Ohio River Bridges Citizen's Advisory Group

Project Item Number: 5-118.00

Section 1 Kennedy Interchange Area Advisory Team Meeting No. 5 October 26, 2006

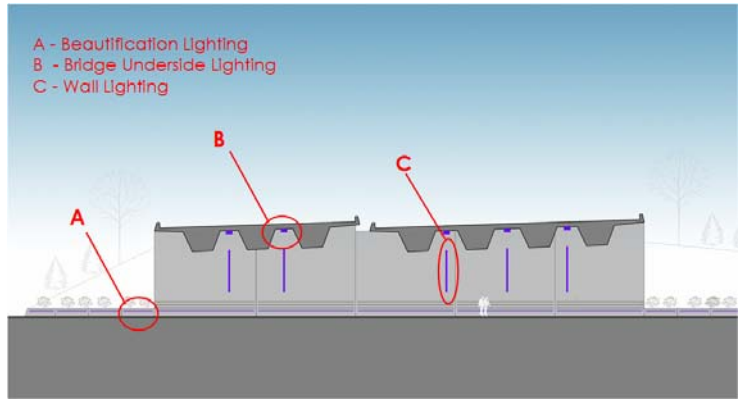
8C. The sidewalks on Main and Market should be larger than currently proposed (15' minimum width should be considered) and the sloped abutment walls should be made vertical. This will allow those gateways to serve as gathering areas with displays of public art. The lighting could be designed to accommodate paintings/murals on the abutment walls by "framing" the paintings; the wider sidewalks will provide both gallery viewing areas and adequate space for pedestrian travel.
